*EASTERN CONNECTICUT
ENVIRONMENTAL
REVIEW TEAM
REPORT*

**Lake Farms
Subdivision**

**Review Date: June 20, 1989
Report Date: September 1989**

**LAKE FARMS SUBDIVISION
LEBANON, CONNECTICUT**

SUBDIVISION PLAN

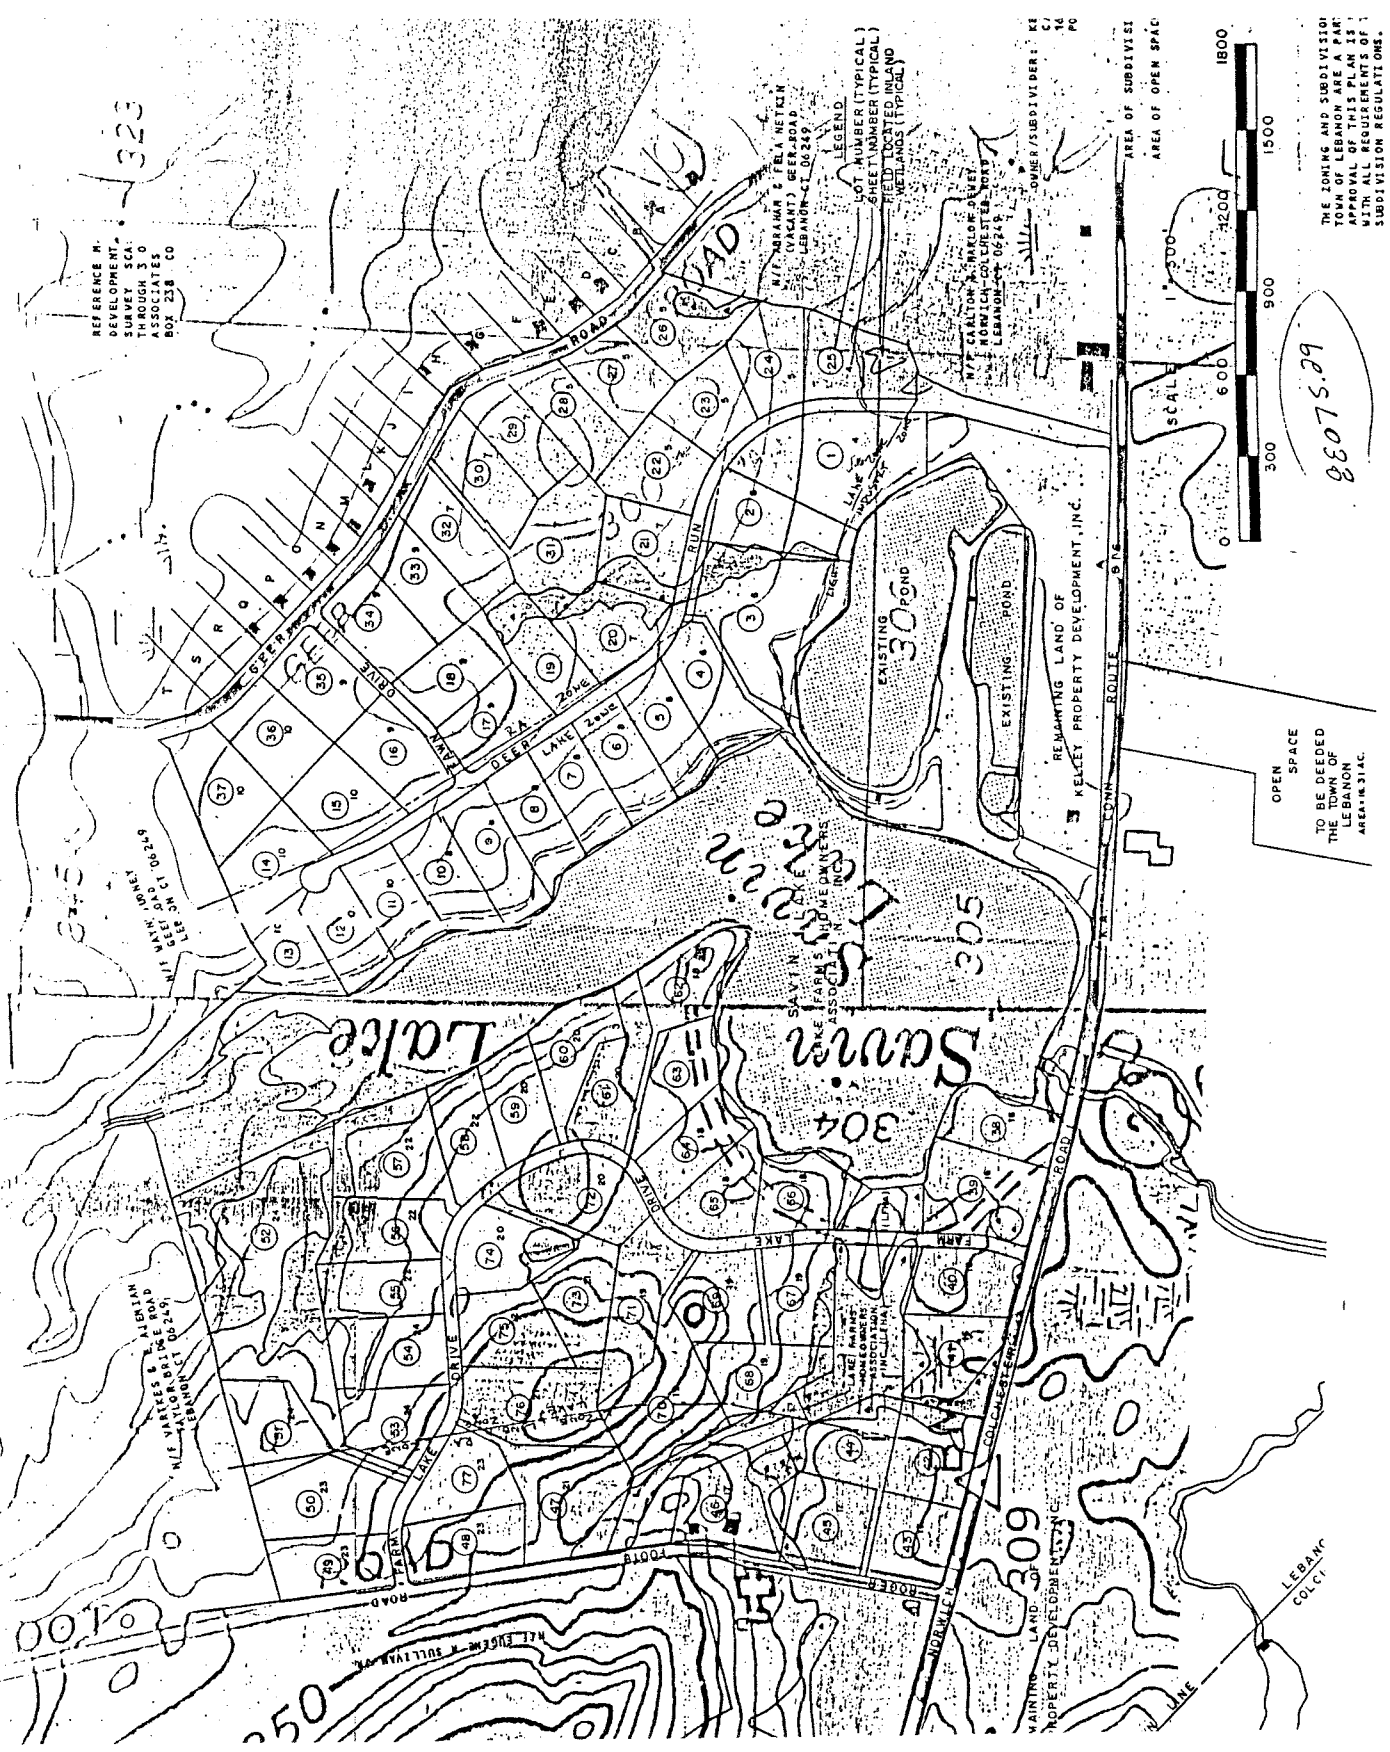
The narrative states disturbances will be kept to a minimum. This area should be delineated on the site plan. Cleared material should be stockpiled or properly disposed of and these areas should be located on the site plan and discussed in the narrative. Proper erosion control devices should be employed.

Grading proposed on house lots should be on the site plan.

Present plans indicate that stormwater arising from new roads and some driveways will be artificially collected in catch basins and piped to various outlet points near streamcourses, ponds, and/or wetland areas. It is not known if roof leaders, footing drains or curtain drains will be tied into the stormwater drainage system. Because these waters would be clean for the most part and because the permeable soils covering most of the site have the ability to absorb the water collected mentioned in the preceding sentence, every effort should be made to encourage infiltration to groundwater on the site. Since road runoff can be a source of pollutants e.g. road sand, hydrocarbons, etc., final discharge points which must be approved by the town should not be discharged directly to watercourses, ponds or wetlands on the site. The stormwater management system should consider reducing runoff by maximizing travel times by using grass or rock-lined channels in lieu of stormwater sewers.

The plans provided to the Team are lacking in information pertaining to stormwater structures, maintenance, and flows. In addition to the drawings which were provided, a stormwater management plan which outlines and explains the flow volume and treatment systems for stormwater should have been included. A stormwater management plan is usually broken down by individual watersheds of each drainage system. The stormwater management plan should be in a format which can be clearly understood by commission members. If commission members feel they do not have the expertise to evaluate the stormwater management plan, professional guidance should be sought from the town engineer, New London County Soil Conservation District, or a consulting engineer with experience in this area. The cost of this service will be justified if it will prevent a costly lake restoration program.

Review of the information which was provided indicates that the existing ponds to the east will receive the majority of the stormwater. This will increase the overall flow of these ponds and may produce a flooding problem. The plan indicates a 24 inch reinforced concrete pipe will be installed to connect this pond to Savin Lake. This will introduce the water quality problems of Savin Lake into the smaller existing ponds. Therefore, the feasibility of draining all the stormwater directly into Savin Lake should be studied. If the stormwater can be routed to Savin Lake, the water quality of the smaller ponds will not be compromised. This may allow the home owners association to use the smaller existing ponds for bathing.

Single family homes are permitted on 2 acre lots in all of these zones, except the I - zone. A small portion of the rear of proposed Lots 1, 2 and 3 lie within the I - zone. Re-zoning, variances, or modification of the proposed rear lot lines may be necessary.

The plan to allow water from Savin Lake to flow over Farm Lake Drive, as it currently does over the existing driveway is not appropriate, since in flood events this road would need to be closed. A box culvert spanning the existing spillway would be appropriate.
